SITE IMPROVEMENTS

67 ENTERPRISE DRIVE

BML TOOL, INC.
 67 ENTERPRISE DRIVE
 MONROE, CONNECTICUT

This document has been prepared in response to the comments below received from the Monroe Engineering Department on 02/24/2022. Responses from JEA are in [blue](#)

S-1

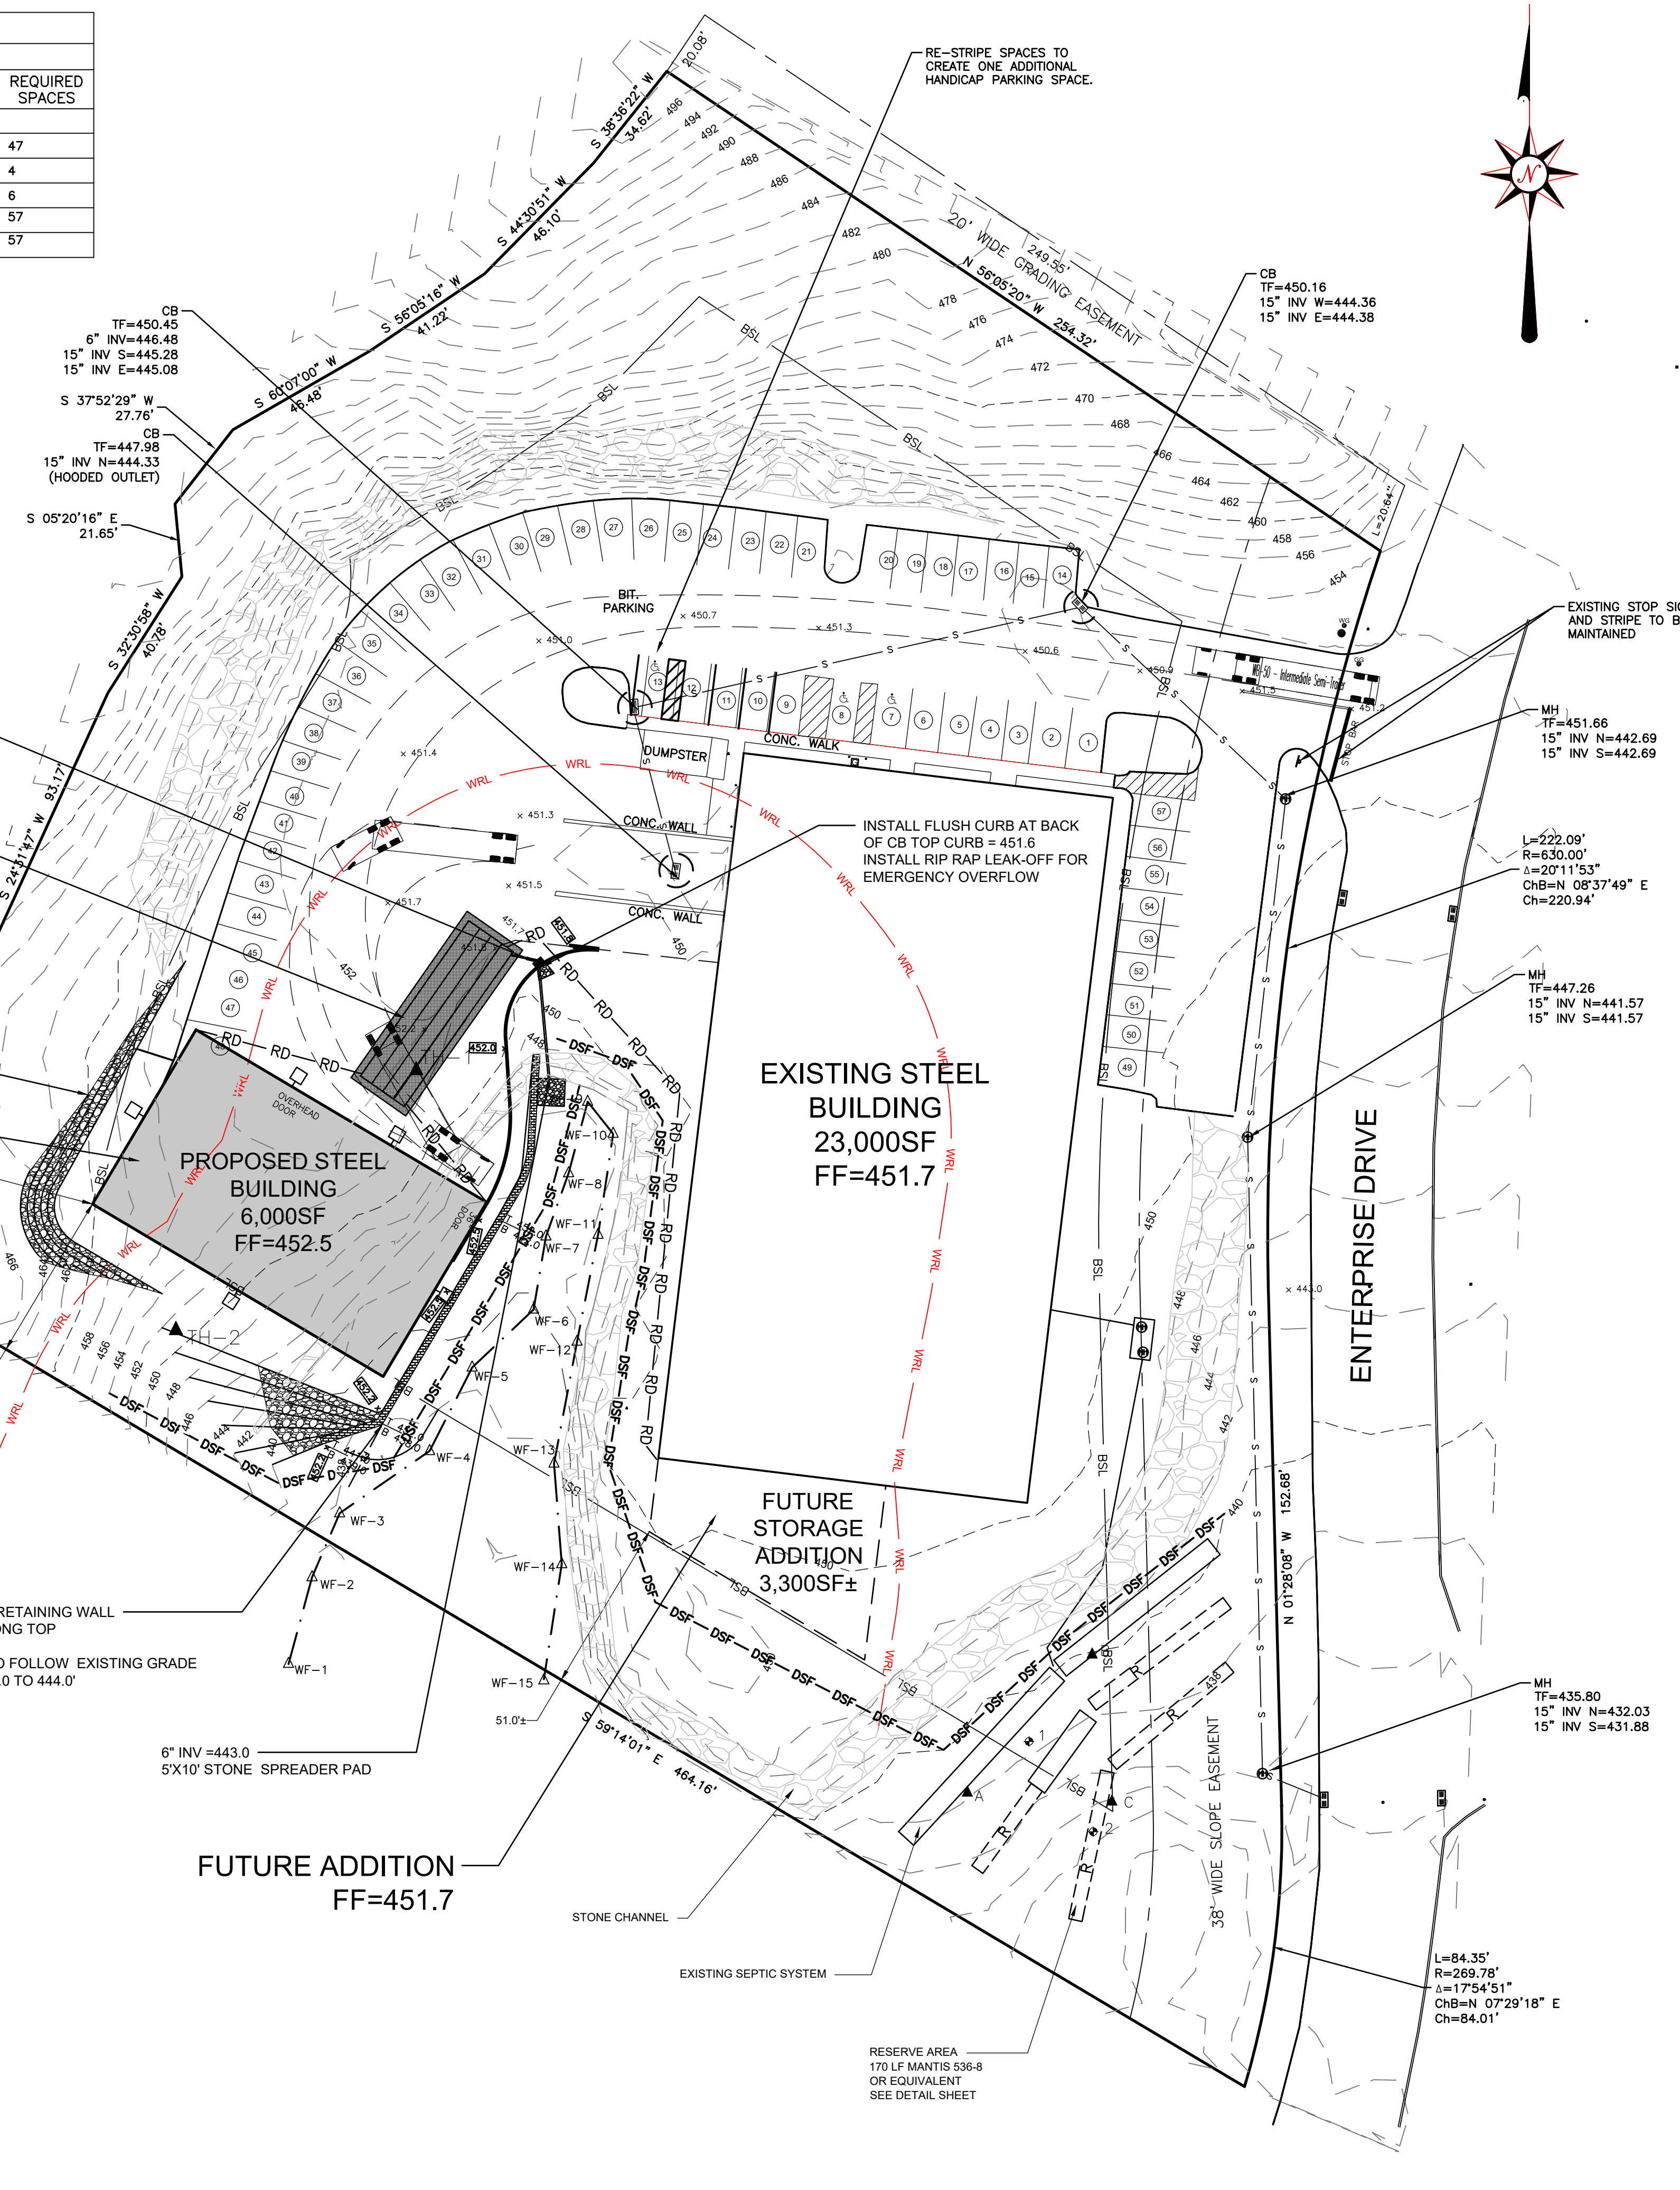
3. The plan indicates a hooded 12” inlet pipe in the catch basin, but the detail shows the hood on the catch basin/manhole outlet. Accordingly, the plan notations should be revised to match the detail.

4. In reviewing the plan in comparison to the stormwater management plan (calculations), it appears that the pipe size/data on the plans is the opposite of the intended layout. Accordingly, the plans should be revised to reflect a 5” outlet leaving the detention system,

and a 12" outlet leaving the catch basin/manhole. Also a detail of the restriction of the 6" pipe to 5" size should be provided.

7. How will the runoff at the southeast corner of the proposed building be handled (show spot elevation at the southeast corner of the building, and grades off the easterly side of the building)? Will runoff flow over the wall?

[This has been revised](#)

[It is intended for the runoff to flow to the rear and over the riprap slope. Spot elevations have been added](#)
